Re: S/D 90-17 - THE LANDING 2ND ADDITION

At the regular meeting of the Subdivision Committee of the Metropolitan Area Planning Commission on Thursday, April 5, 1990, the above captioned plat was considered. The action of the Committee was to approve the preliminary and authorize preparation of the final plat, subject to the following:

STAFF REPORT
(Final Plat; Preliminary Plat Approved 4/5/90)

CASE NUMBER: S/D 90-17 - THE LANDING 2ND ADDITION

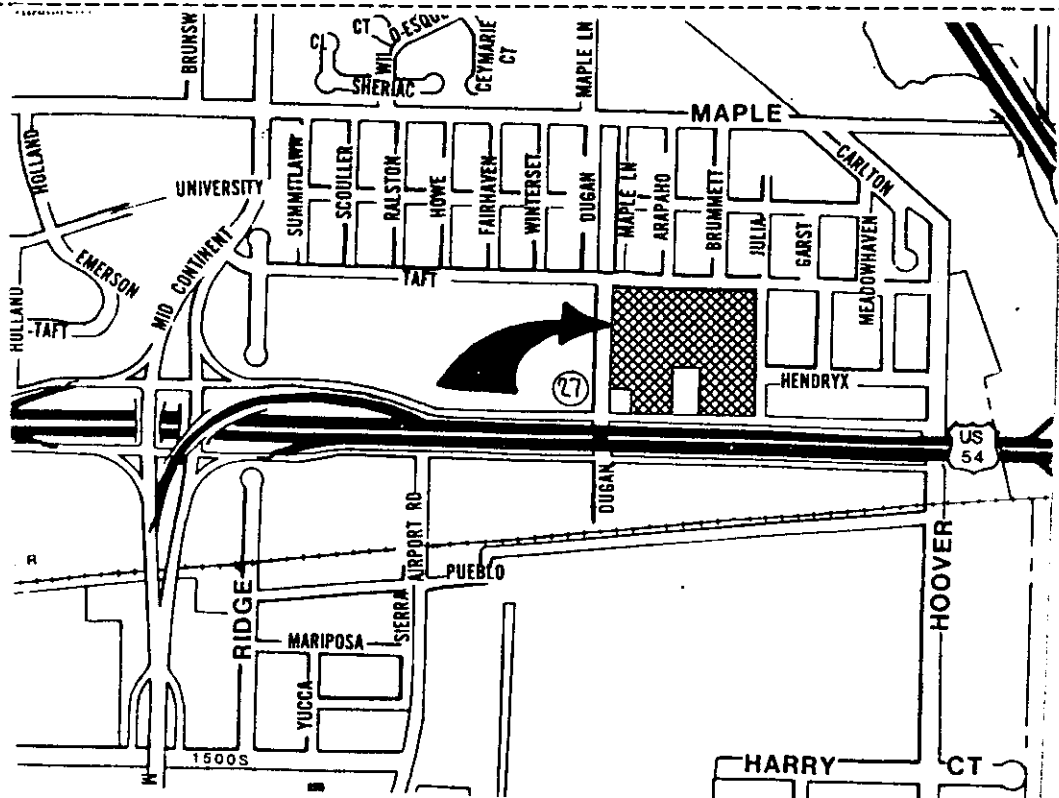
- NOTE: This is a two lot replat of THE LANDING and AIR PARK 2ND ADDITION. Both lots have existing commercial uses and are a part of THE LANDING C.U.P. (DP-150 Amendment No. 2). Basically, the plat proposes lot areas that correspond to C.U.P. parcel boundaries as proposed in the current C.U.P. amendment being reviewed.

- A. Square footage figures shall be provided for the lots within this plat so existing special assessments and petitions may be amended.
 - B. The applicant shall submit an avigational easement covering all of subject plat and a restrictive covenant assuring that adequate construction methods will be used to minimize the effects of noise pollution in the habitable structures constructed on subject property.

- C. Since this plat is indicating the platting of complete access controls from Lot 1, to the intersection of Julia and Kellogg Drive, the plattor's text shall be amended on the final plat tracing to also indicate this dedication.

- D. On the final plat tracing it shall be indicated if the minimum building pad elevation involves the lowest floor or opening elevation.
 - E. At the time of submitting the final plat tracing, the applicant shall submit a marked copy of the plat indicating the location of the various drainage easements, K.G.& E. easement, access easement, etc. listed in the tile binder of this plat. If these items are off-site and do not impact this plat there locations shall be noted and explained on the marked plat. If on-site, copies of the documents establishing these easements shall be provided for the plat file.

- H. Perimeter closure computations shall be submitted with the final plat tracing. Section 5-101(c).
 - I. Recording of the plat within 30 days after approval by the City Council.

- J. The representative from City Engineering should be prepared to comment on the status of the applicant's drainage plan. Also, Engineering needs to indicate if the minimum building pad elevations are acceptable.

STAFF REPORT
(Preliminary Plat)

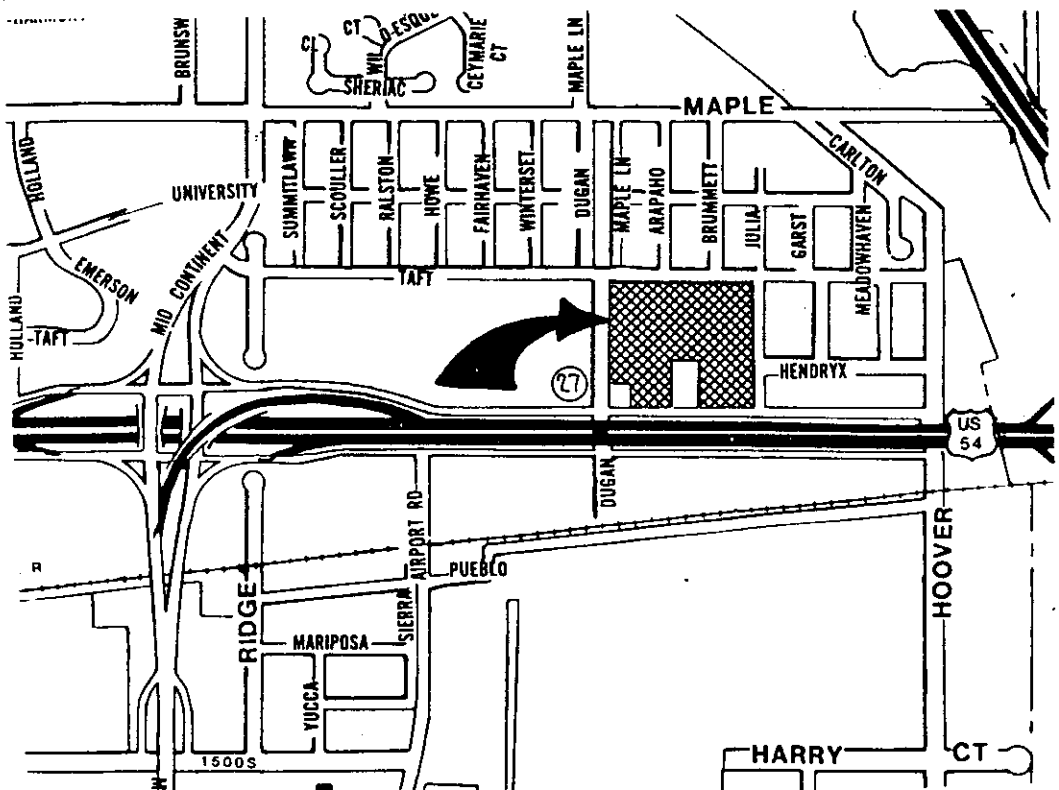
NOTE: This is a two lot replat of THE LANDING and AIR PARK 2ND ADDITION. Both lots have existing commercial uses and are a part of THE LANDING C.U.P. (DP-150). Basically, the plat proposes lot areas that correspond to C.U.P. parcel boundaries as proposed in the current C.U.P. amendment being reviewed.

- A. The applicant shall either abandon or amend the existing petitions on file for this property. If projects are to be abandoned as a result of this replat, the applicant shall pay off the charges against the abandoned projects. Square footage figures shall be provided for the lots within this plat so existing special assessments and petitions may be amended.

- D. The final plat shall indicate for Lots 1 and 2, "complete access control" to Kellogg (U.S. 54) across the south line of Kellogg Drive adjacent to this plat.

- E. The final plat shall indicate any appropriate condemnation case numbers for Kellogg (U.S.54).
- F. The applicant shall install or guarantee the installation of all utilities and facilities which are applicable and described in Article 8 of the MAPC Subdivision Regulations.

- I. Prior to or at the time of submitting the final plat, the applicant shall submit a drainage plan to City Engineering for review and approval.
- J. The representatives from the utility companies should be prepared to comment on the need for utility easements to be platted on this property.

- K. The representative from City Engineering should be prepared to comment on the status of the applicant's drainage concept.
